Re: New P/N 28226 OEM MRM Bracket

Note: This technical bulletin serves as an addition to the KP/ZD Design, Installation, Maintenance, & Recharge Manual P/N 20150 Amerex Restaurant Fire Suppression System dated February 14th, 2019. This technical bulletin is not meant to replace any requirements and/or limitations within, and the information in the bulletin will be added at the next revision. This bulletin defines a new UL LISTED COMPONENT.

Figure 1: *OEM MRM Bracket (P/N 28226)*

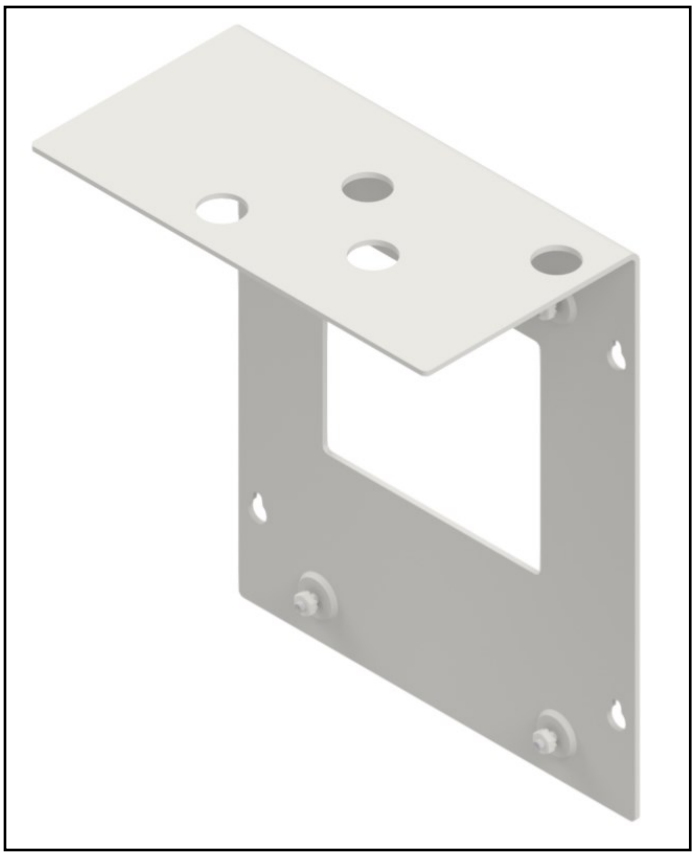
The new OEM MRM Bracket (P/N 28226) is now available for use with Amerex systems. This bracket shall be assembled with the MRM actuator assembly (P/N 11977) ONLY in a protected enclosure. This option is an alternative for mounting MRMs in an already enclosed space. The OEM MRM Bracket (P/N 28226) will be packed with the MRM (P/N 11977) as P/N 28318.
